**Proponent:** David W. Cooper, Stairway Manufacturers' Association

**Revise as follows:**

**1012.3 Handrail graspability.** All required handrails shall be of one of the following types or provide equivalent graspability.

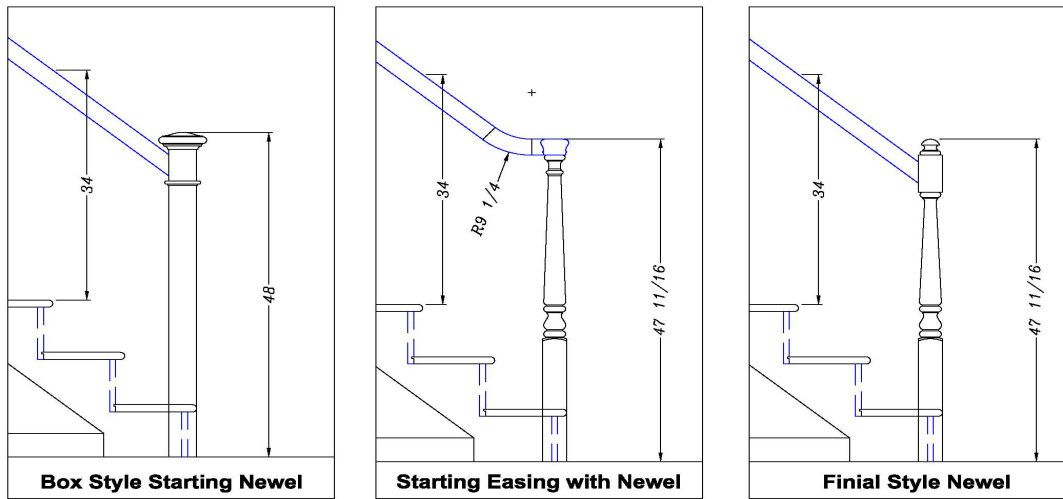
**Reason:** The proposed change will make editorial corrections required as well as clarify the use of newels

The need to allow the use of a newel at intersections of the rail in dwelling units at a turn in the stair to provide for the use of newels within a flight has been recognized and allowed within the IRC and should be included in the IBC to allow lower cost options that have not caused any known attributable safety issues.

The editorial change in the preposition from "on" to "over" more clearly describes the position of the listed items to the lowest tread and has been used in the IRC with consistent interpretation.

**1012.4 Continuity.** Handrail-gripping surfaces shall be continuous, without interruption by newel posts or other obstructions.

1. Handrails within dwelling units are permitted to be interrupted by a newel post at a turn stair landing.
2. Within a dwelling unit, the use of a volute, turnout, ~~or~~ starting easing or starting newel is allowed ~~on~~ over the lowest tread.
3. Handrail brackets or balusters attached to the bottom surface of the handrail that do not project horizontally beyond the sides of the handrail within 1.5 inches (38 mm) of the bottom of the handrail shall not be considered obstructions. For each 0.5 inch (12.7 mm) of additional handrail perimeter dimension above 4 inches (102 mm), the vertical clearance dimension of 1.5 inches (38 mm) shall be permitted to be reduced by 0.125 inch (3 mm).

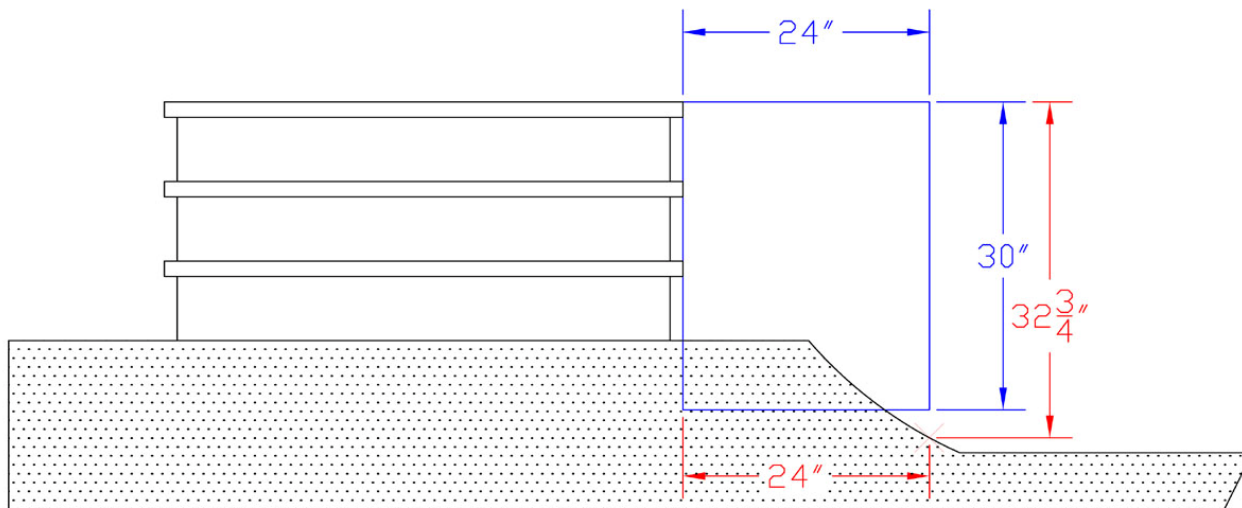
**Reason:** The purpose of the code change is to provide fixed points for measuring the 30 inch vertical riser height of elevated surfaces to determine if guards are required.

Though Sections 1013.1 and R312.1 state that guards are required when the walking surface is 30 inches or more above the walking surface below, it does not define clearly where to measure that vertical measurement. This proposed code change gives a set of parameters as to where to make the measurements. The author used the 24 inch measurement that is published in the BOCA 1996 building code, section 1825.0 retaining walls, section 1825.5 guards, as the determining distance or point of reference for when retaining walls where required to have guards.

The diagram below was drawn by the author and is shown as a visual guide or technical drawing. The drawing shows a 3 riser front entry stoop with 7-3/4" risers from a front elevation. The ground is detailed in outlined dots. The 24" horizontal with 30" vertical box shows the area in which the code change submits the measurements should be taken. The 32-3/4" vertical point shows the deepest point within the 24" horizontal edge measurement.

Thus if this stoop was on a home it would require a guard be installed on the right side only as the left side is not 30 inches or more deep.

**1013.1 Where required.** Guards shall be located along open-sided walking surfaces, mezzanines, industrial equipment platforms, stairways, ramps and landings which are located more than 30 inches (762 mm) above the floor or grade below, measured vertically from the edge height of the open-side to the deepest point no more than 24 inches (610 mm) horizontal off the open-side edge. Guards shall be adequate in strength and attachment in accordance with Section 1607.7. Where glass is used to provide a guard or as a portion of the guard system, the guard shall also comply with Section 2407. Guards shall also be located along glazed sides of stairways, ramps and landings that are located more than 30 inches (762 mm) above the floor or grade below. Where the glazing provided does not meet the strength and attachment requirements in Section 1607.7.
